Case Number: 2021-2355-ZC

## ZONING STAFF REPORT

# CONCEPTUAL PLAN FOR REZONING HONEYBEE SUBDIVISION

**HONEYBEE SUBDIVISION**  
GREEN SPACE EXHIBIT AND CIRCULATION PLAN

**PUD-1**

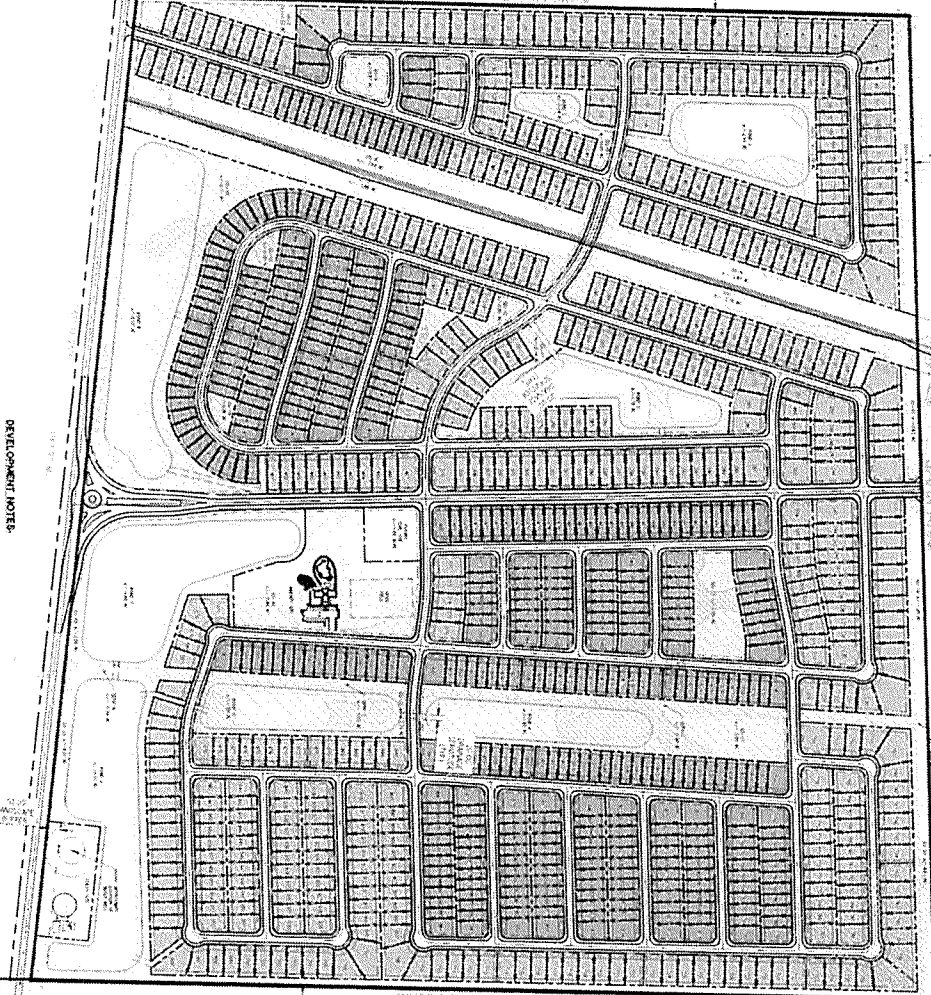
- As shown in Table 1, the Honeybee PUD is providing eighteen-35 ft. wide lots for the construction of Cottage Style homes. This means that 944 of the 968 lots fluctuate by a width of 10 feet. Staff has determined that these lot sizes ~~and~~ do not provide the diversification and variation of residential uses encouraged by the Planned Unit Development.

1. The applicant is required to name the service provider for the proposed 962 home sites including sewer and water connections.
2. As submitted, there is no diversification of single-family housing types. Staff has determined the 18 proposed cottage style home sites does not provide diversification and variation in the relationship of residential uses.

Response: The PUD Ordinance requirements allow for flexibility in lot sizes to promote diversification as well as allows for a tradeoff due to the increased greenspace requirements in comparison to straight single family residential zoning. The diversification of the lots provided and green space shown in the proposed PUD achieves this objective of the PUD. We request that staff provide where the Ordinance defines diversification as it pertains to lot size and product type. We are aware of a multitude of subdivisions developed within St. Tammany Parish that only provide for 2 lot sizes. Our proposed PUD accounts for 4 lot sizes (not just the 3 listed above), which vary in range by upwards of 40% in size. Below is the summary of the different lot sizes and percentage of the total lot count for each type.

Response: Again, the Ordinance does not provide specifications on what qualifies as lot diversification. Please show us where in the PUD regulations require more than 4 different lot sizes. These different lot sizes allow multiple different floor plans for each lot size thus allowing the development to target residents at multiple different stages of life. Again, there are numerous locations and numerous PUDS that only have 2 different lot sizes. We are proposing 4 different lot sizes. We request Staff show us where this does not meet the diversification and variation requirements.

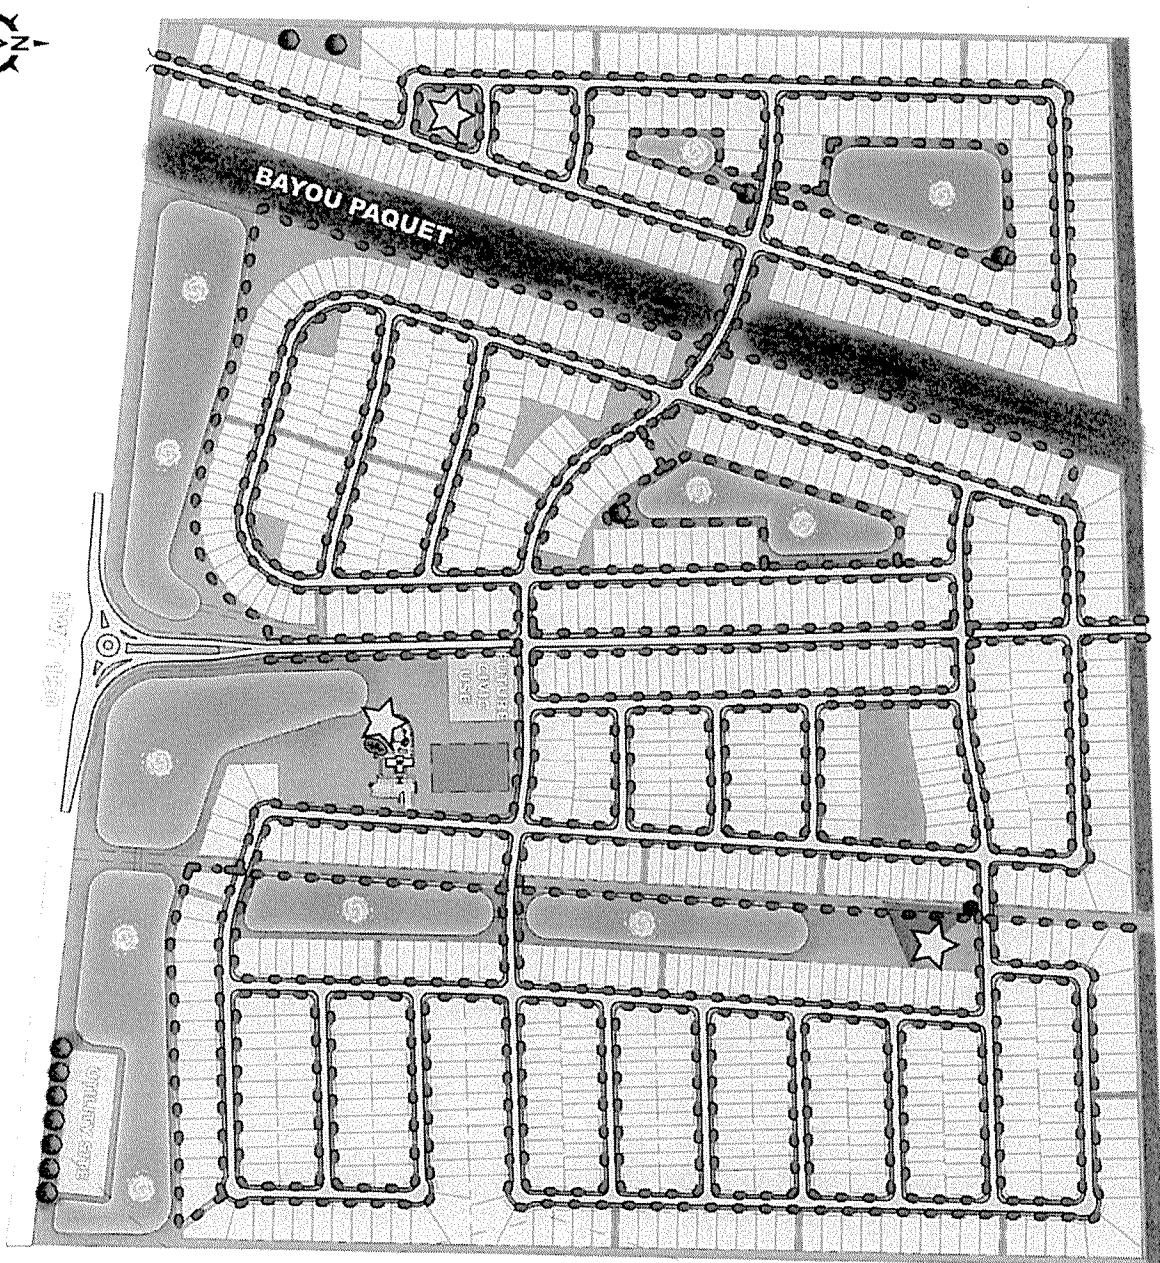
- The applicant has provided a "PUD Walking Exhibit" which shows a ½ mile radius circle centered on each park location. This plan illustrates that every lot in the development is within ½ mile from a playground. In addition, the developer has agreed to add parking at all playground locations to ensure that every home has reasonable access.

GREENSPACE CALCULATIONS

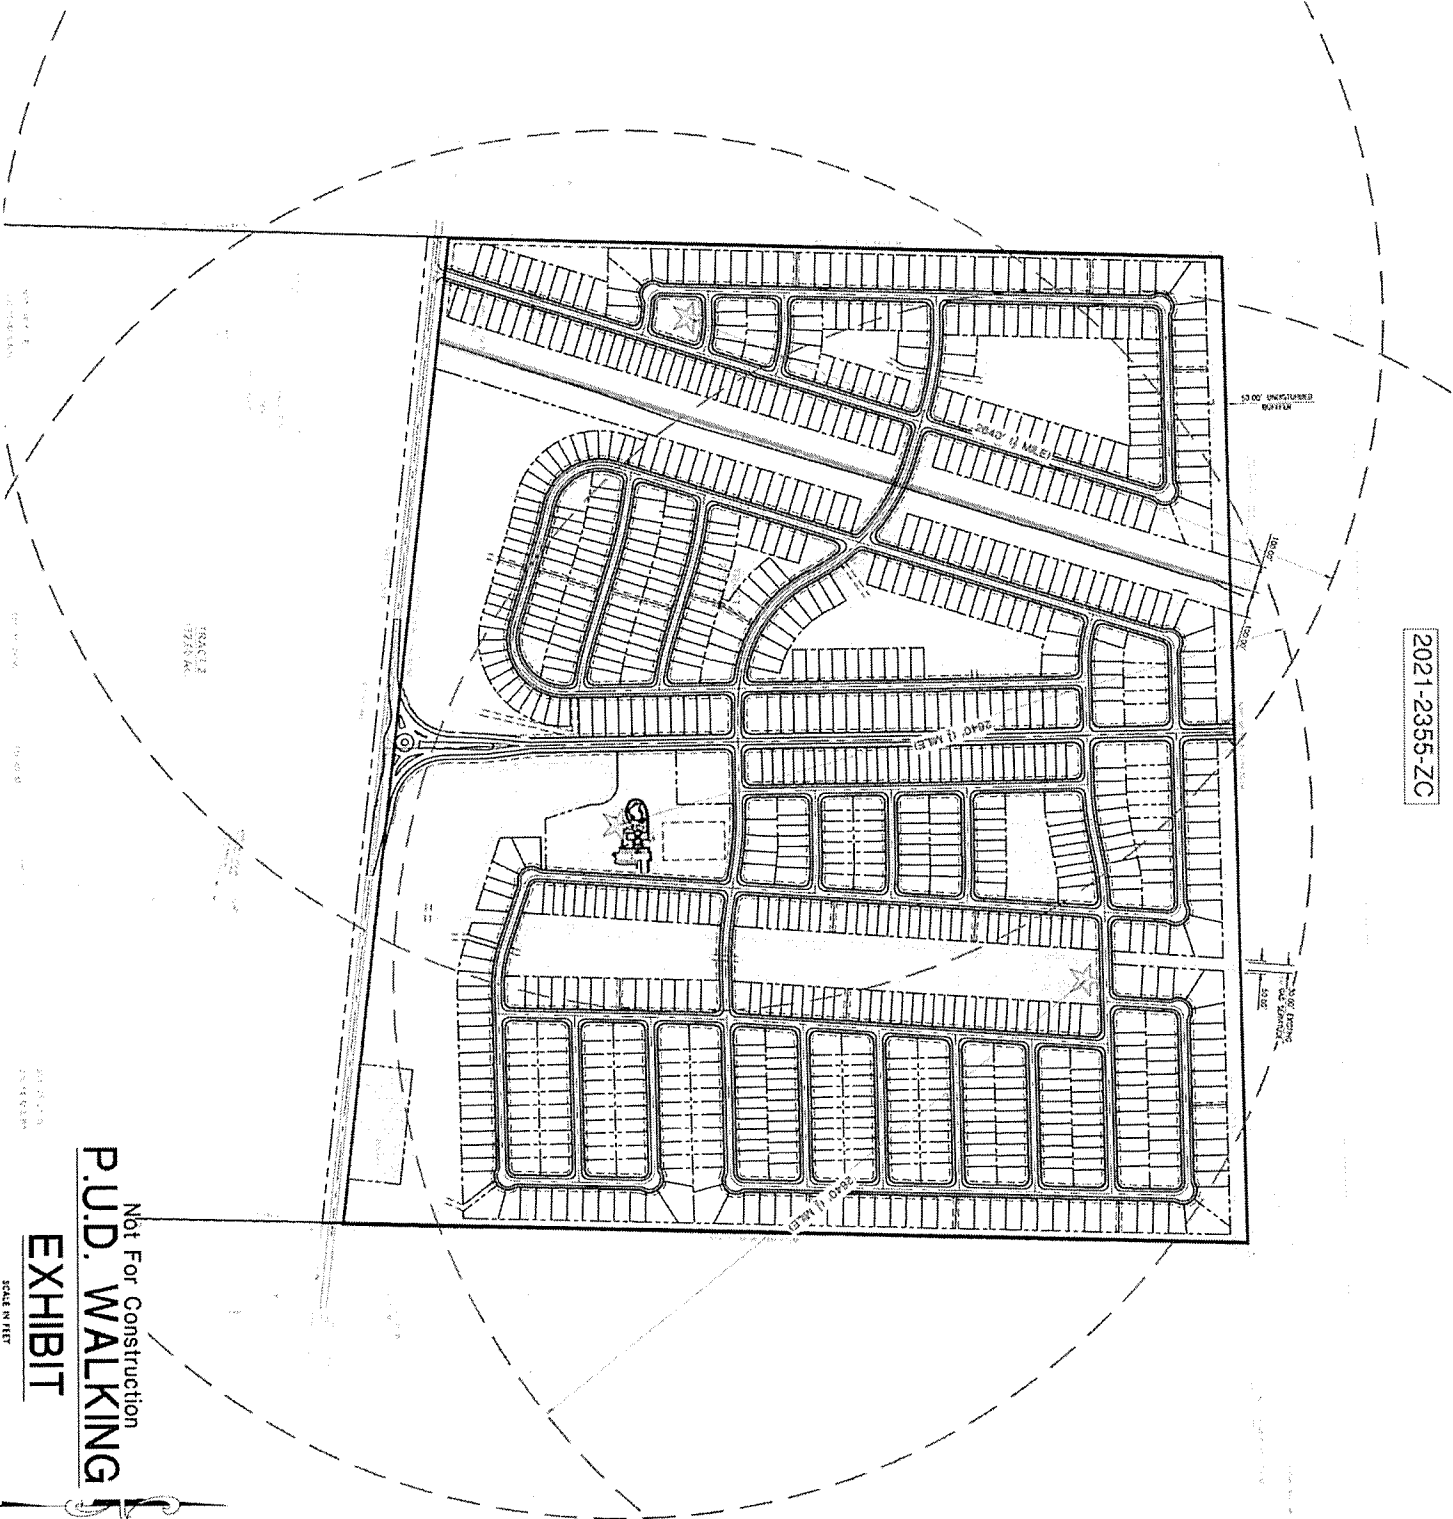
Staff has concerns that a large majority of the greenspace provided is comprised of easements, servitudes, and buffers, and therefore ~~does not meet the intent of the PUD requirements~~ is not of a higher quality than would be possible without the PUD. (see Table 4). ~~While not opposed to the addition of several acres of pocket parks situated throughout the PUD, staff would like to see that more amenities are added to these parks to ensure the greenspace that is provided is functional and beneficial to the residents. Currently, it appears as though the Honeybee PUD is providing three playground sets and an "open field" to accommodate 962 proposed home sites.~~ As per Table 4, if the applicant eliminated Bayou Paquet, the gas servitude, "space around the lakes", and buffers from the total amount of greenspace provided, the PUD plan would be providing 36.59 acres, which is merely 53% of the greenspace required.

\*This illustration is not meant to show that the proposed amenities would not meet the subdivision ordinance, but rather to note that 47% of the greenspace provided on the PUD plan is comprised of easements, servitudes, and buffers which would not be permitted if the property were to be developed without the PUD overlay and is therefore not of a higher quality.

Response: Per Section 130-1674(a)(8)(c), the proposed PUD that has been developed and submitted to staff meets the minimum open space requirements. A copy of this ordinance is below for your reference.

Our current proposal provides 69.08 acres of open space. As previously mentioned, the servitudes, buffers, and "space around the lakes" are allowed to be counted toward greenspace per the UDC. Additionally, our proposed development enhances these areas by providing landscaping and paved walking paths in these greenspace areas.
